FEDERAL COMMUNICATIONS COMMISSION

MEDIA BUREAU
AUDIO DIVISION
APPLICATION STATUS: (202) 418-2730
HOME PAGE: <http://www.fcc.gov/mb/audio/>

In re: WEOS (FM); Geneva, NY
Colleges of the Seneca
Facility ID No. 65559
CP application BPED-20070907ADI

Construction permit application BPED-20070907ADI requests a change in channel for WEOS, from Channel 209 (89.7 MHz) to Channel 208 (89.5 MHz) to improve the signal coverage of WEOS. One component of the application is a request for waiver of Section 73.509 of the Commission, as the 100 dBu interfering contour of WEOS would be located within the 60 dBu service contour of third-adjacent channel station WCIY, Canandaigua, NY. Your waiver request describes the small extent of the prohibited contour overlap caused within WCIY's service area and computes the population within that area. You believe that waiver of the rule is warranted under the circumstances set forth in the application.

LAMBERT EQUAL AREA MAP

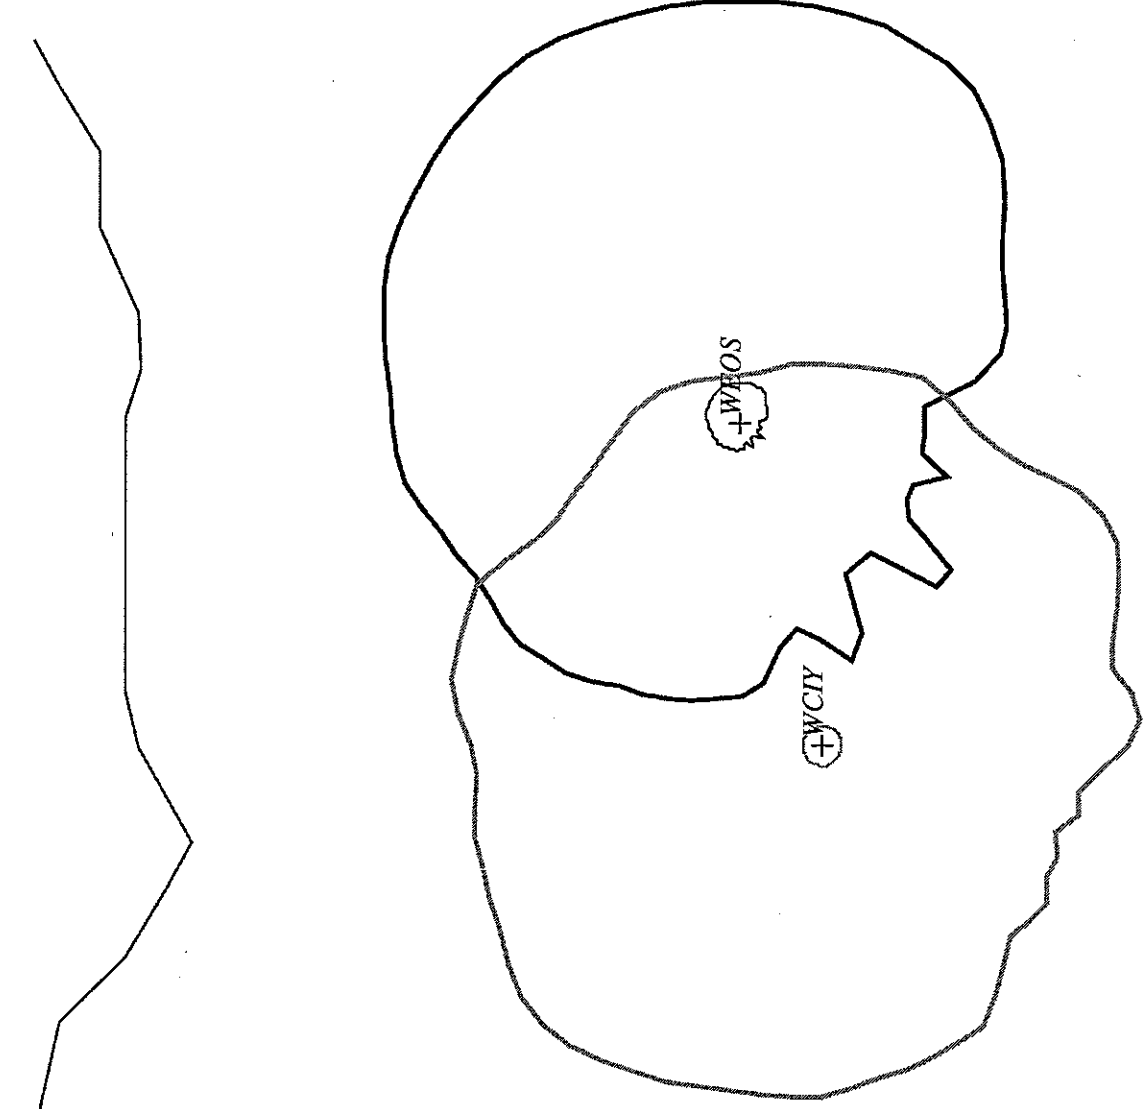
Under present procedure, waiver requests of prohibited contour overlap caused (as here) will only be considered with the written consent of the licensee of the opposite station (here, WCIY). As of this time, we have nothing from the licensee of WCIY before us. Consequently, we will afford you a period of 60 days from the date of this letter either to secure the written consent of the licensee WCIY, or to otherwise amend the application so as to eliminate the prohibited contour overlap (via a site move toward the east).

Further action on this application will be withheld for a period of 60 days from the date of this letter to afford you an opportunity to provide the requested information. Failure to respond within this time period will result in the dismissal of application BPED-20070907ADI for failure to prosecute, pursuant to Section 73.3568(a)(1) of the Commission's Rules
